Fwd: Euston Area Plan Update -Proposed Submission Draft 2026 Representation Form

Euston Area Plan Update – Proposed Submission Draft 2026 Representation Form

OBJECTION REGARDS SITE ALLOCATIONS EA4 AND EA5

EUSTON AREA PLAN – PROPOSED SUBMISSION DRAFT (JANUARY 2026)

Above: section through existing office building, with 40m height indicative height guidance for redevelopment

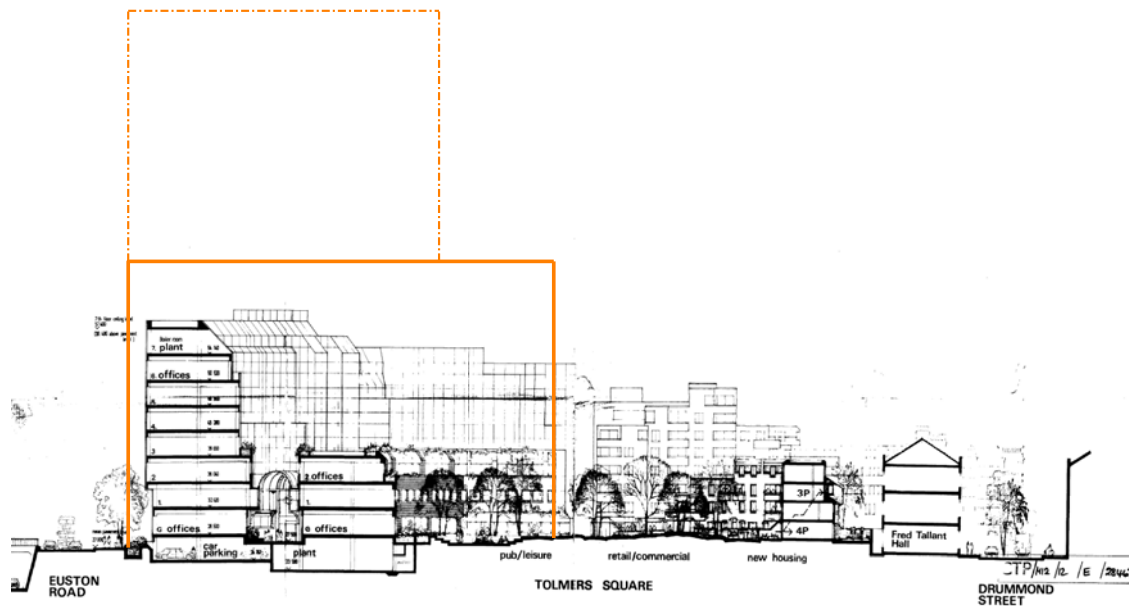
The existing building has a very specific structure comprising three layers: an outer layer of office space, 8 storeys (32m) high, a glazed triple height atrium, and an inner layer of office space (incorporating the pub) that is 3 storeys (12m) high. It is suggested that a possible height of 40m may be suitable with a 75m residential tower. This is shown in the following image, which is an original drawing showing a 'section' cut through the existing building, with the 40m height outline shown in the solid orange line. The dashed line is the 75m residential tower behind.

Any pretence that the allocated use can be achieved by retrofitting the existing is misleading and not in accordance with the statements in the Development and Design Principles (see above), for the following reasons:

- 'A tall building' on the corner of Euston Road and North Gower Street will require demolition of the east end of the existing building. This will irretrievably damage the existing building and its operation.
- It is not possible to 'enhance workspace provision' (euphemism for enlarging) without changing the existing building configuration. It would require demolition of the atrium and three storey block as a minimum.
- Neither is it possible to provide retail and provide an active frontage without fundamentally changing the structure of the building, including the underground car park.

Above: Site allocation Jul 2024

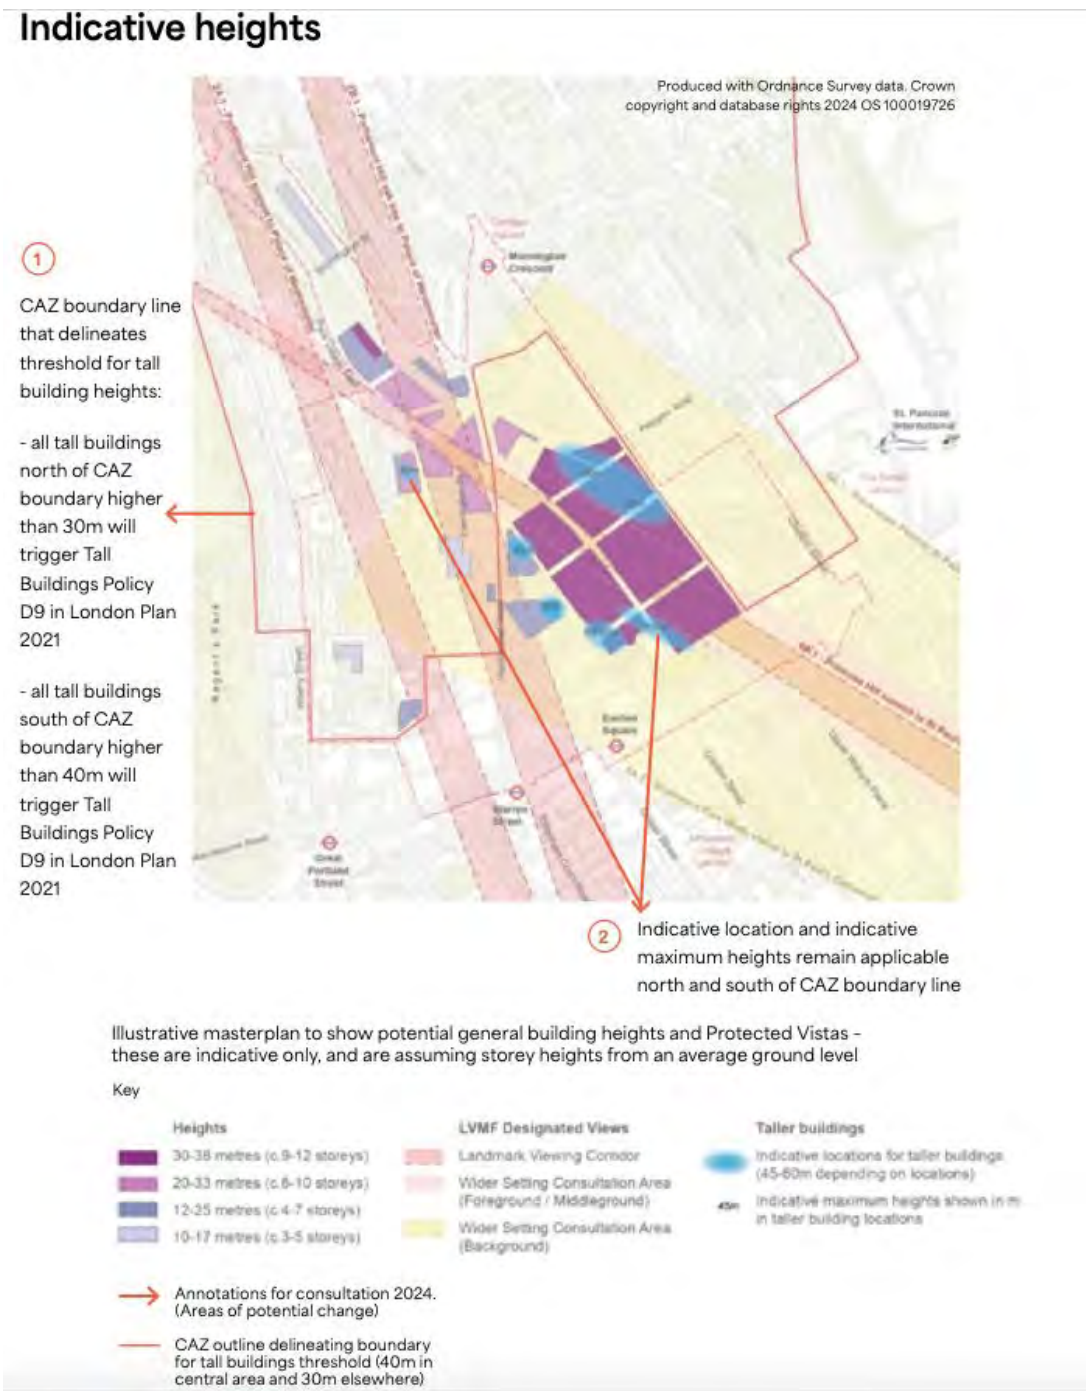
The site allocation for 250 Euston Road was included in the July 2024 consultation, but it did not include a 75m high residential tower or height up to 40m. It did not show the site boundary cutting across the public open space.

The site allocation in July 2024 was numbered (5) and was titled "Euston Circus Building" which is not the name of the building, and not one that local people would recognise.

Site allocation (5) did not show up on the overall plan of site allocations which showed the height restrictions (see extract from the July 2024 consultation report below):

Above: photo looking towards 250 Euston Road, at the junction of Hampstead Road and Euston Road

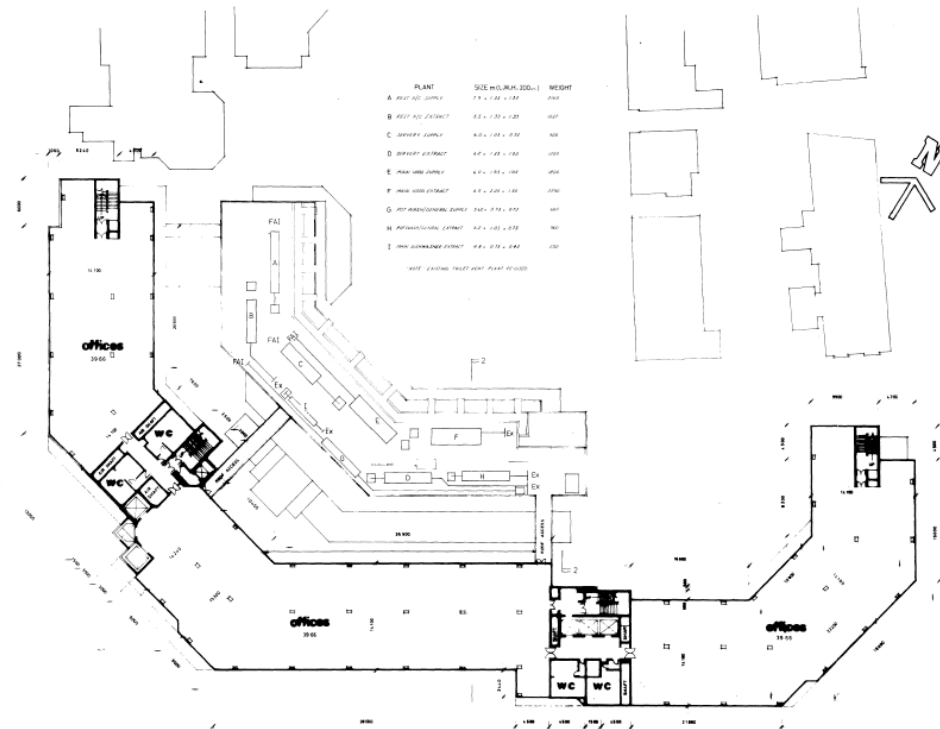
250 Euston Road was developed by Stuart Lipton, as his first venture with Greycoat. It was designed by architects Renton Howard Wood Levin in 1979 and was completed in 1981. Originally built for Prudential Insurance, it is now occupied by UCLH NHS Foundation Trust. It used high quality external walling, which steps around the corner of Euston Road in a bold and architecturally innovative manner. It provides a shield to the social housing to the north, protecting it from noise, pollution and wind. It was the first mirror clad office building in London. It was well built and has stood the test of time well.

Above: layered space, internal atrium and external area

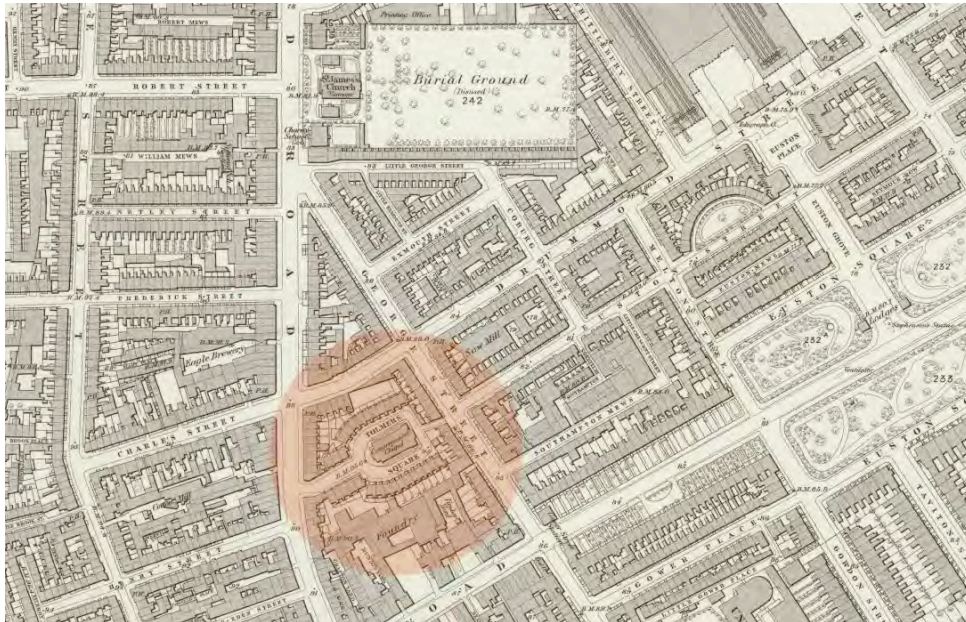
Internal materials include Travertine, marble and terrazzo. The atrium is paved with brick to read as part of the external space. Original fixtures and fittings survive throughout the building.
